SUBJECT: ST. LUCIE PLANT, UNIT NO. 2 - ISSUANCE OF AMENDMENT REGARDING
PRESSURE VESSEL FLUENCE TO 55 EFFECTIVE FULL-POWER YEARS OF
OPERATION (TAC NO. MD8040)

Amendment No. 154
Renewed License No. NPF-16

SAFETY EVALUATION BY THE OFFICE OF NUCLEAR REACTOR REGULATION

**FIGURE 3.4-2
ST. LUCIE UNIT 2 REACTOR COOLANT SYSTEM PRESSURE-
TEMPERATURE LIMITS FOR 55 EPY, HEATUP, CORE CRITICAL, AND
INSERVICE TEST**

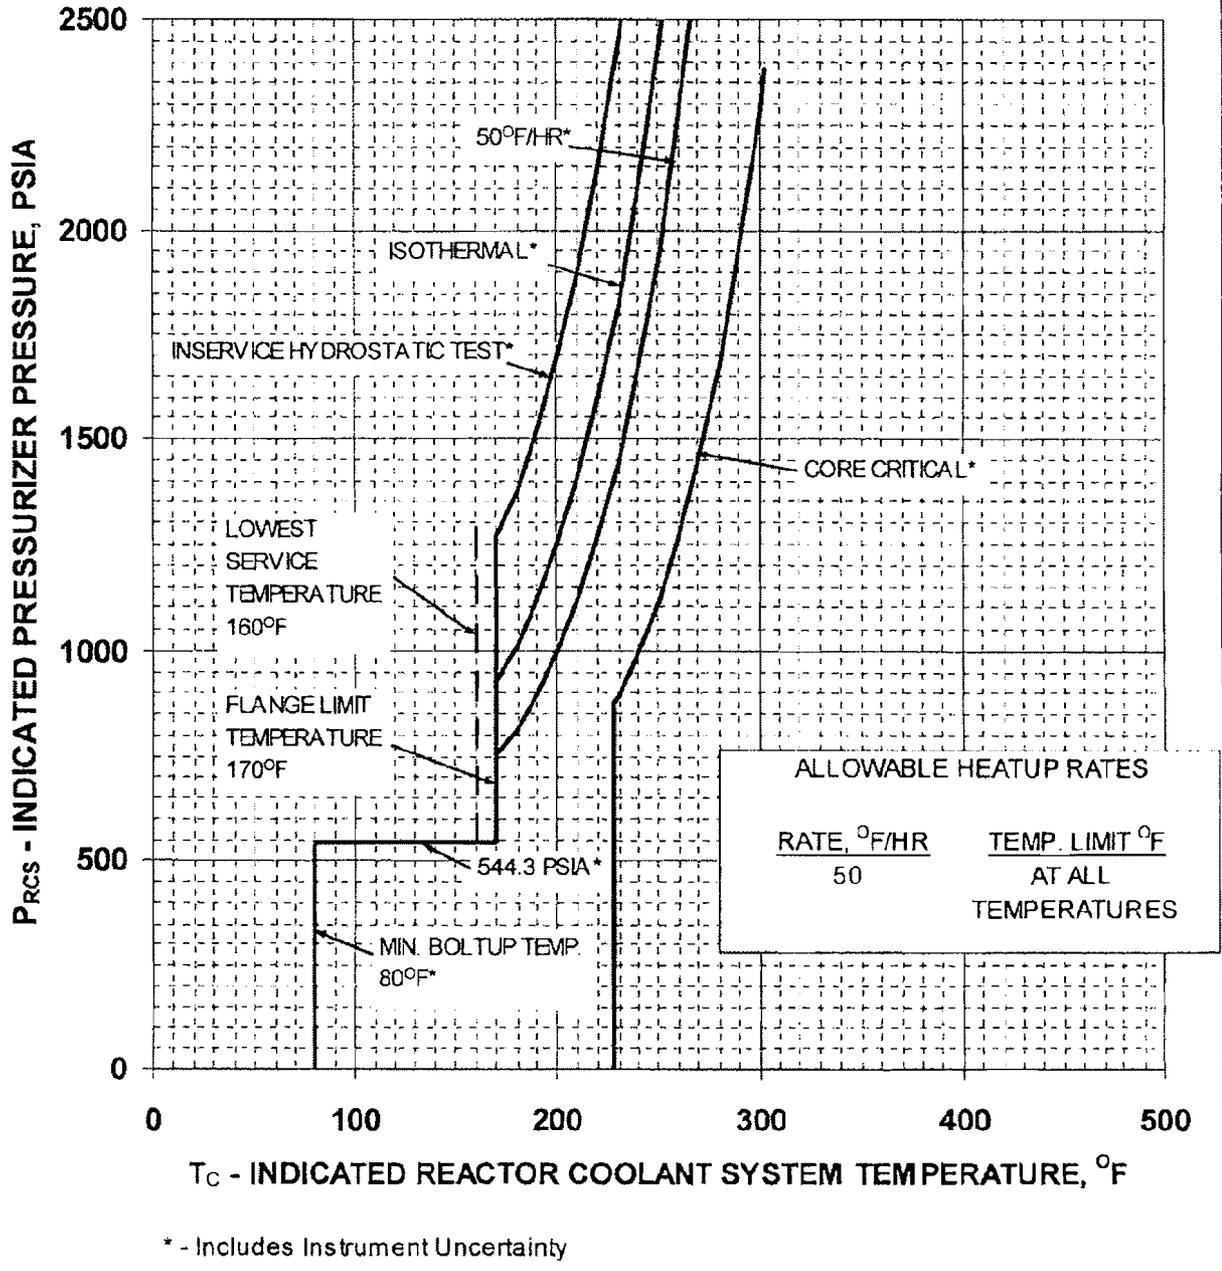
This amendment extends the pressure temperature (PT) limit curves and the low-temperature overpressure protection (LTOP) setpoints for operation to 55 Effective Full-Power Years (EFPYs). The current PT limit curves (and the LTOP setpoints) are applicable to 21.7 EFPYs. The new PT limits and LTOP setpoints will be applicable to 60 calendar years which includes the period until the end of the renewed operating license.

- Modified RCS P-T limit curves to include instrument uncertainty and the inservice hydro test line for the new heatup curve.
- New cooldown curve containing 100 °F/hr and 75 °F/hr cooldown rates since the lower rates allow higher pressures than are allowed by the lowest service temperature and flange limitation restriction.
- P-T limit curves extended to 55 EFPY.
- LTOP system setpoints and LTOP system T_{enable} values to reflect the extended period of operation under the renewed license. The PORV lift setpoint has been raised from ≤ 470 pounds-per-square-inch absolute (psia) to ≤ 490 psia.

The proposed P-T limit curves in the January 23, 2008, letter modified the P-T limit curves by including margins to account for control room instrument errors (10 °F) and pressure instrument errors (91.7 pounds-per-square inch differential). The staff also found that the minimum temperature requirements of Table 1 of Appendix G to 10 CFR Part 50 were properly implemented in the P-T limit curves. Therefore, the staff verified that the licensee's proposed P-T limits are in accordance with Appendix G to Section XI of the ASME Code and satisfy the requirements of Appendix G to 10 CFR Part 50. The proposed P-T limit curves also satisfy GL 88-11, because the methodology in RG 1.99, Rev. 2 was used to calculate the ART.

3.4.9.1 The Reactor Coolant System (except the pressurizer) temperature and pressure shall be limited in accordance with the limit lines shown on Figures 3.4-2 and 3.4-3 during heatup, cooldown, criticality, and inservice leak and hydrostatic testing.
